## SERVICE TECHNICAL INFORMATION

### ONE POINT REPAIR

REF. NO. : SI-95-011  
CUSTOMER RELATION & SERVICE DIV.

MODEL : AM-F1

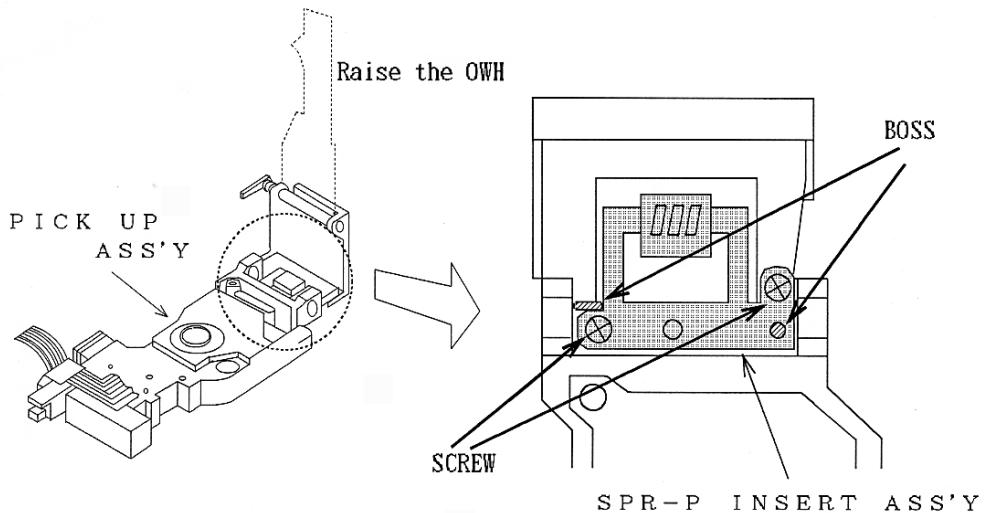
CONTENTS: Due to a faulty thread system in the AM - F1 model. "Caution" appears during play-record.

SYMPTOM : Caution is indicated during play/record, or 5~6 seconds after start play back. Also, the set can not work when placed on stand the set (input/output terminal facing up).

- (1) Disassemble the set and remove the PICK UP ASSY. (Always short the short round of the PICK UP flexible wire.)
- (2) Remove the faulty SPR-P INSERT ASSY from the PICK UP ASSY.
- (3) Insert a new SPR-P INSERT ASSY between the two bosses and secure with screws.

**Note:** If the SPR-P INSERT ASSY is secured with screws after being incorrectly inserted between the bosses, it may become deformed and the above symptoms will recur. Pay careful attention when inserting the SPR-P INSERT ASSY.

Ref.	Parts Name	Parts No.
—	SPR-P, INSERT ASSY	87-046-415-010
